Entergy Nuclear Operations, Inc.
Palisades Nuclear Plant
27780 Blue Star Memorial Highway
Covert, MI 49043

Palisades Nuclear Plant
Docket 50-255
License No. DPR-20

License Amendment Request: Emergency Core Cooling System Surveillance Requirement

SCHEMATIC OF CONTAINMENT
SUMP ENTRANCE PATHWAYS
AFTER PLANNED MODIFICATION
(NOT TO SCALE)

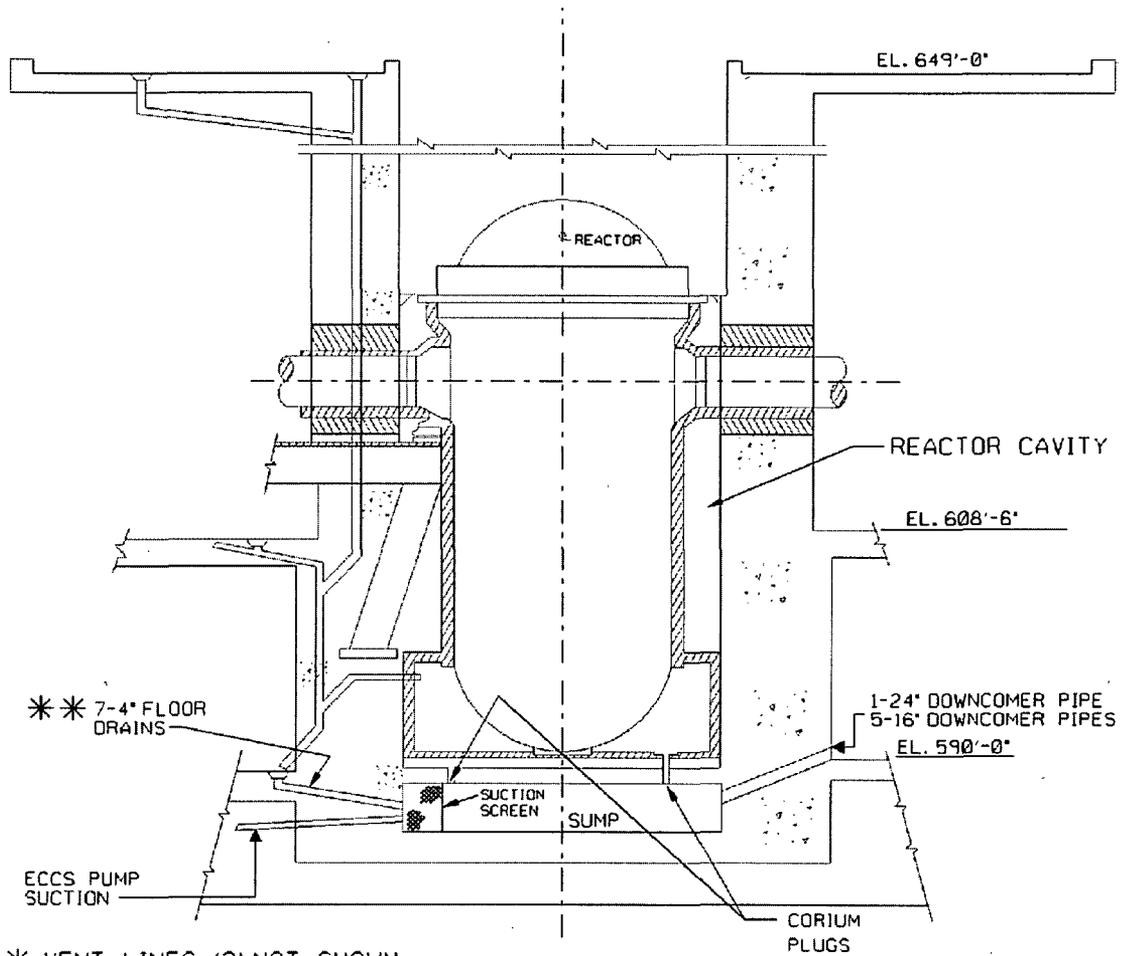
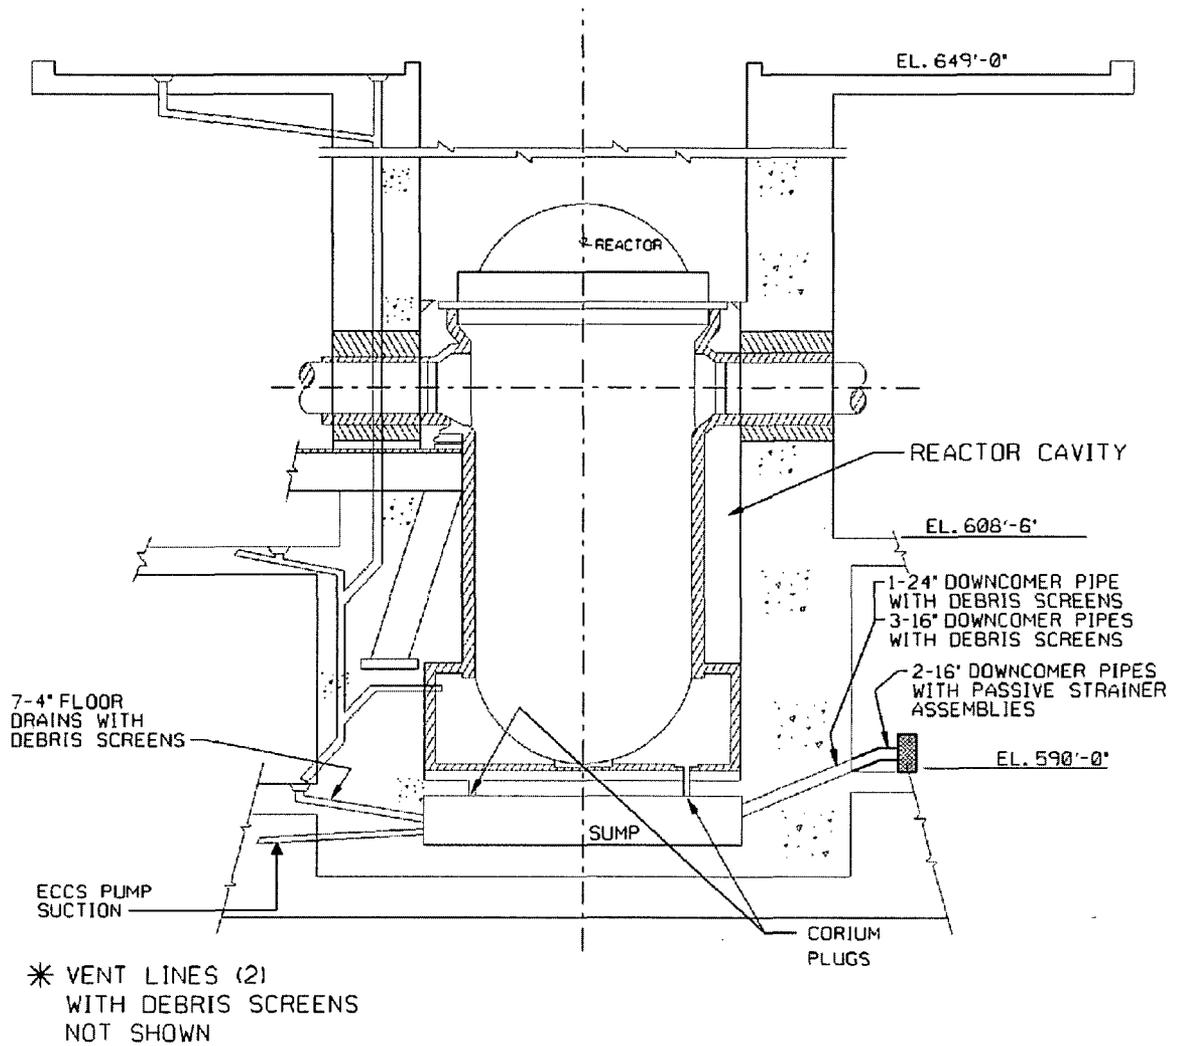
ENO's planned modification removes the existing ECCS suction inlet screens. In lieu of the ECCS suction inlet screens, ENO is planning to install passive strainer assemblies on the 590 foot elevation of containment. The passive strainer assemblies would connect to the containment sump via two containment sump downcomer pipes. These two containment sump downcomer pipes would provide the post-LOCA credited flow pathway from the passive strainer

assemblies to the containment sump to provide a suction source of water to the ECCS and CSS pumps. Attachment 2 provides a figure that schematically reflects the containment sump entrance pathways after the planned modification.

In addition to the passive strainer assemblies, debris screens are to be installed on the remaining open containment sump entrance pathways, which include the four remaining downcomer pipes, the seven containment floor drains, and the two containment sump vent lines. The debris screens are intended to intercept and segregate debris outside of the containment sump envelope. The reactor cavity corium plugs, located in the reactor cavity drain lines, contain pellets within the corium plug tube, tube end cap, and tube bottom cup support assembly which form a debris interceptor similar to the debris screens. These containment sump entrance pathways do not provide a credited post-LOCA flow path into the containment sump envelope. PNP housekeeping standards would be used to ensure that these containment sump entrance pathways are not restricted by debris. The proposed SR includes a requirement to ensure that these containment sump entrance pathways show no evidence of structural distress or abnormal corrosion. Including this requirement in the surveillance provides assurance that there are no barrier breaches that would allow debris to enter the containment sump and cause downstream equipment damage.
